Please find below the response to the request for review for the CDM project with the title "Yunnan Jinping Miao-Yao-Dai Autonomous County Kesikou Hydropower Station", with the registration number 2064, In case you have any further inquiries please let us know as we kindly assist you.

## **Response to the CDM Executive Board**

**Figure 1. Electricity Connection**

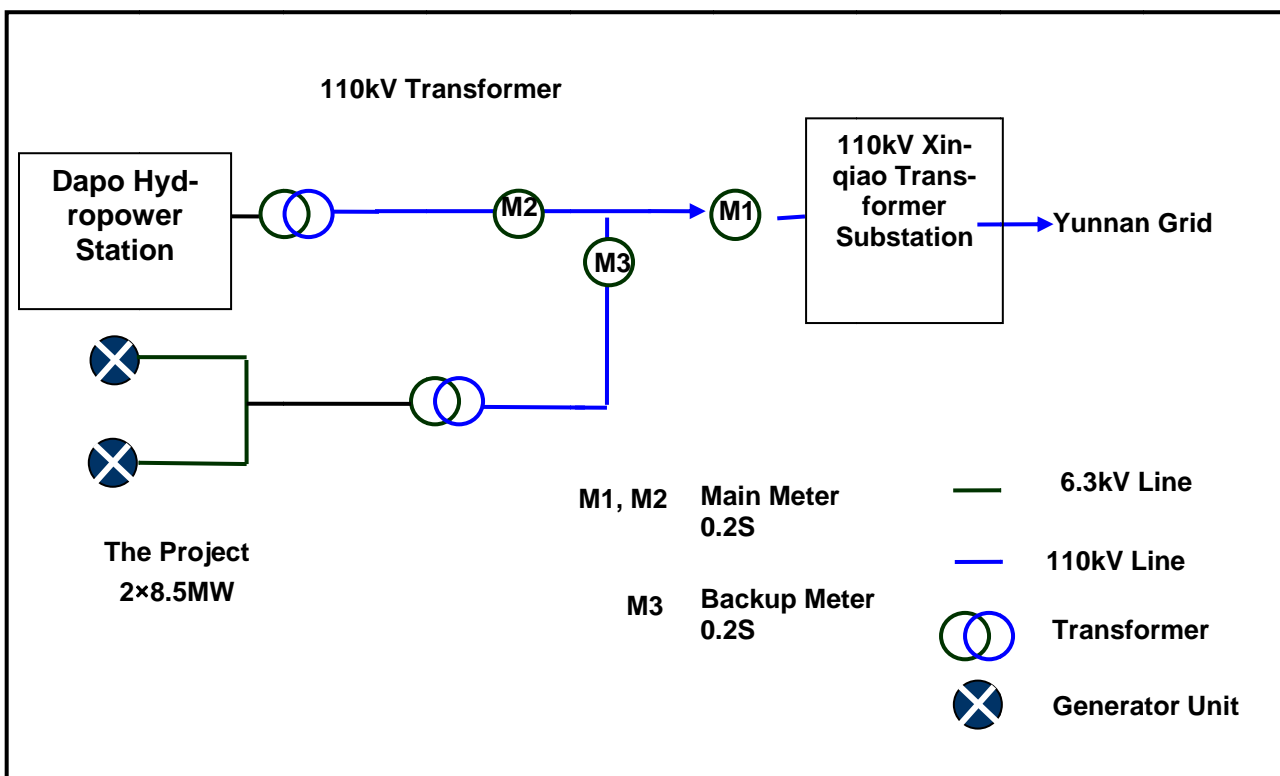
**2. Further justification is required how the power output of this project activity can be accurately and separately monitored from the Dapo hydropower station.**

The electricity generated by the project will combine the electricity generated by the Yunnan Jinping Dapo Hydropower Station (here after as “Dapo Hydropower Station”), which has been also registered as a CDM project, and then the electricity generated by the two projects will be exported to the Xinqiao Transformer Substation, which belongs to the Grid Company. (More details please see the electricity connection figure below).

Three meters (bi-directional) will be required, of which, The first meter (M1, main meter, 0.2S), which is located at the input of the Xinqiao Transformer Substation of the Grid Company, will be employed to measure the power supplied to the grid by the project and Dapo Hydropower Station (M1<sub>a</sub>) and the power supplied to the two power stations by the grid (M1<sub>b</sub>).

The second meter (M2, main meter, 0.2S), which is located at the exit of Dapo Hydropower Station, will be employed to measure the power supplied to the grid by the Dapo Hydropower Station (M2).

The third meter (M3, backup meter, 0.2S), which is located at the exit of the project will be employed to measure output electricity of the project (M3<sub>a</sub>), and the power supplied to the project from the grid (M3<sub>b</sub>).

M1 and M2 will be monitored by the grid company; M3 will be monitored by the project owner.

At first TÜV SÜD can confirm that three meters will be installed as required and power generated by the proposed project will join the electricity produced by another registered project named "Yunnan Jinping Dapo Hydropower Station". Based on the installation of three meters, it is clear that the generated electricity from the proposed project and the Yunnan Jinping Dapo Hydropower Station will be measured separately. The electricity generated by "Yunnan Jinping Dapo Hydropower Station" and electricity delivered to the meter Xinqiao Transformer Substation will be monitored by the grid company while the electricity generated by the proposed project will be monitored by the project participants. TÜV SÜD confirms that the approach of monitoring the electricity is applicable and plausible.

The total electricity produced by both project will be transferred to the Xinqiao Transformer Substation, which belongs to the Grid Company. More detail can be seen in figure 1 of project participant's response.
